ISSUE: Permit to Demolish/Capsulate (partial) and Certificate of Appropriateness for alterations and an addition

APPLICANT: Sharon Dow and Louis Alefantis

LOCATION: Old and Historic Alexandria District
114 Princess Street

Minutes from the December 18, 2024 BAR Hearing:

Figure 3. Previously proposed (left) and currently proposed (right) east elevation.

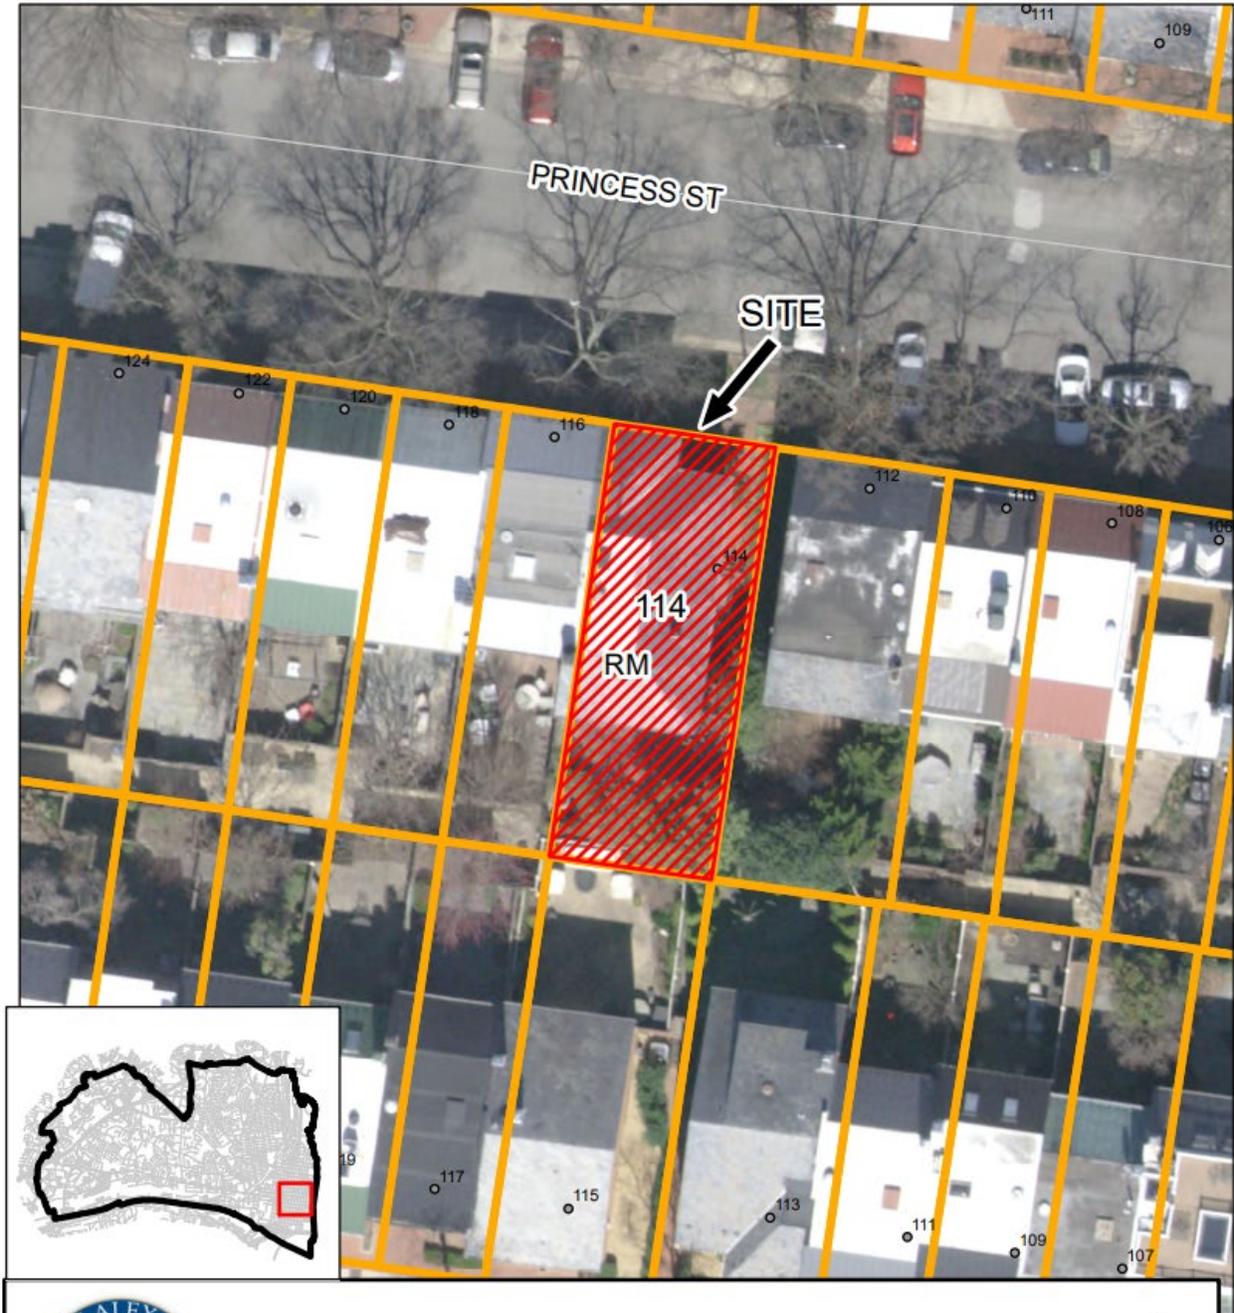
The Board members wanted to see an updated east elevation that keeps some of the details of the existing entry door and creates a more organized window configuration.

Ms. Del Ninno said that the house currently blends in with the neighbors, and she prefers that the applicant match the existing brick and not paint it. She also recommended updating the east elevation, particularly by emphasizing the center door.

This case was last heard at the Wednesday, December 18, 2024 BAR hearing. During that hearing, the Board members raised concerns about the proposed east elevation, and accepted the applicant's request for a deferral so that they could address those concerns. Since then, staff has discussed the Board's concerns with the applicant and the applicant has made several changes in response to the Board's feedback. Staff believes that the updated plans sufficiently address the Board's concerns.

Figure 5. Currently proposed east elevation, with changes from previous proposal labeled.

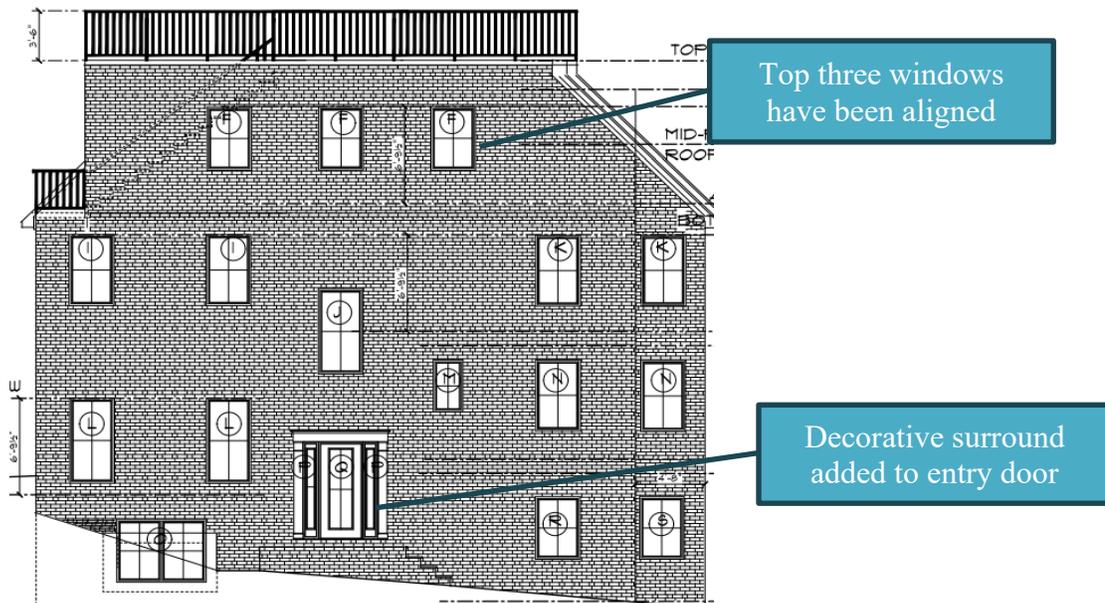
Mr. Scott said that the proposed east elevation has lost some of the house's regal presence as well as the focal point of the door. He recommended emphasizing the entry door more, and said that the window above the door should keep some of the details of the existing door. He also stated that because windows F, G, and H have different sill levels, the applicant should consider making window G shorter or putting a decorative element on top. He said that he believes the proposed window configuration looks too modern and the elevation needs a more classical window configuration.

Ms. Zandian said that window F on the east elevation should be lined up with the lower windows, and that the east elevation should be more symmetrical and organized.

First, in response to Board feedback that the three windows on the top row were misaligned, the applicant has aligned them to create more symmetry. Second, in response to concerns that the previously proposed entry door had lost some of the original entry door's architectural character, the applicant has added a decorative door surround/molding to emphasize its status as the main entry of the home. Staff notes that the visibility of the east elevation is limited by the neighboring property to the east, and most of the southernmost half of the elevation will not be easily visible from the public right-of-way. Thus, staff believes that, when viewed from Princess Street, the proposal will appropriately blend in with the surrounding houses and not appear visually overwhelming.
